Re: Bishop Tube Company
East Whiteland Township
Chester County
Industrial Wastes
W.O. 07 7379-000

ENGINEERING REPORT
BISHOP TUBE COMPANY
FRAZER, PENNSYLVANIA
April 9, 1973

Reviewed by *(Rke)*
6/27/73

BISHOP TUBE COMPANY	
FIGURE 2		EXISTING SCHEMATIC	
STEEL TUBE PICKLING AREA			
MADE	CHG. D.	GILBERT ASSOCIATES, INC.	
ENG.	CF. DPN.	ENGINEERS AND CONSULTANTS	
REV. CM. APP. DATE	7379	READING, PENNA.	
WORK ORDER	SIZE	DRAWING	REV.

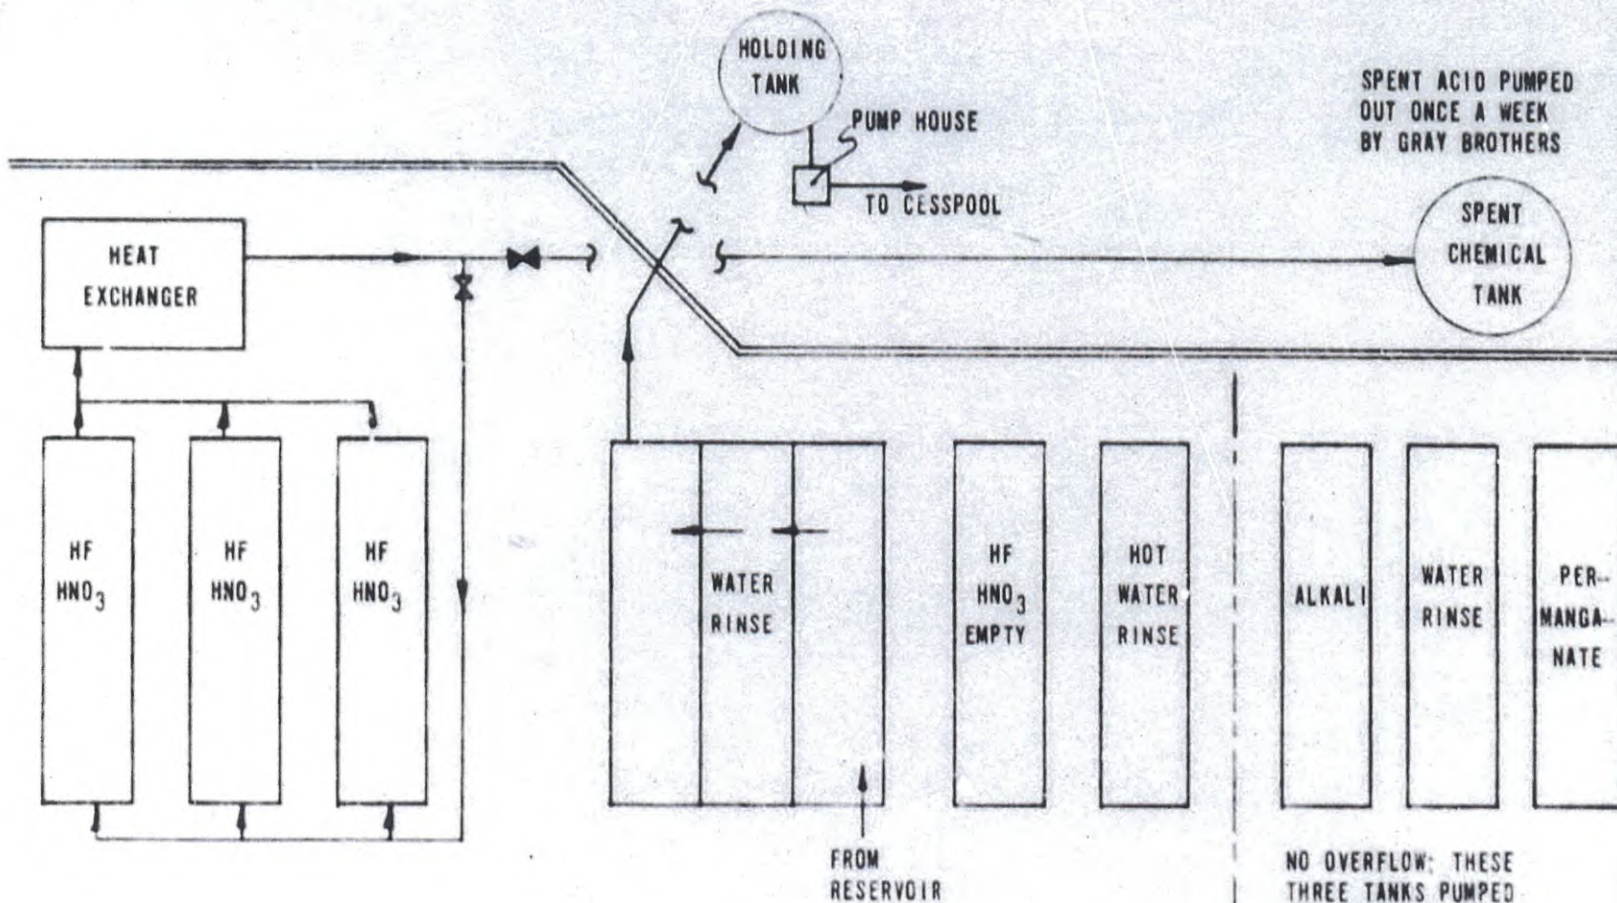
*Rinse water goes in
septic system*

*Iron can be precipitated
(if soluble now) into
a sludge, etc., then
then in a worst
discharge*

For a treatment
